Determination 2006/117

Balcony drainage for a multi-level apartment building at 5 O'Reily Avenue, Wellington

Figure 1: Section through the building.

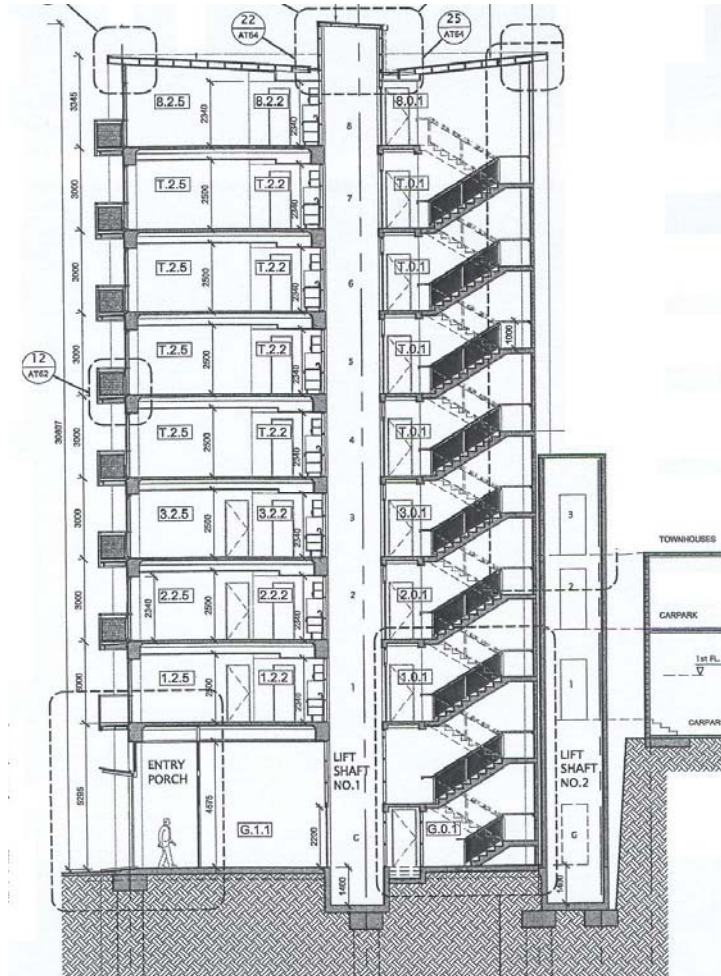
- 1.2 The matter for determination is whether the use of “spillover” stormwater discharge (uniform discharge) from the balconies on the building, Levels 2 to 8 inclusive, complies with the Building Code (First Schedule, Building Regulations 1992).

- 2.1 The building work has been planned and built in two stages. Stage Two consists of seven floors (Levels 2 to 8) (currently partially completed) constructed on the existing Stage One two-storey building (Levels G and 1). The matter in dispute is about the stormwater discharge from the balconies to the Stage Two work, being the balconies from Levels 2 to 8 inclusive.
- 2.2 Levels 2 to 8 each contains three apartments, being 24 apartments in total. It is proposed to construct a cantilevered balcony to each of the 24 apartments constructed on the north elevation of the building. Each balcony will extend to the boundary of the property. The overall size of each balcony is 3480mm x 1025mm (3.567m²) on plan. The balconies are timber-framed and are supported on structural

steel frames. The decks to the proposed balconies consist of 19mm thick “Kwila” close boarding covered with a 1.5mm thick butyl-rubber membrane. Each balcony is to be protected by a balustrade formed from perforated aluminium panels. The stormwater drainage discharge from the decks is a “spill-over” system at the deck perimeters.

- 2.3 At Ground floor there is a continuous verandah canopy, at Level One there is a continuous balcony. Both features have a controlled stormwater disposal system consisting of gutters and downpipes.

- 8.1 In accordance with section 188 of the Act I determine that the proposed amended design of the "spillover" solid decked balconies complies with the provisions of E1 of the Building Code.
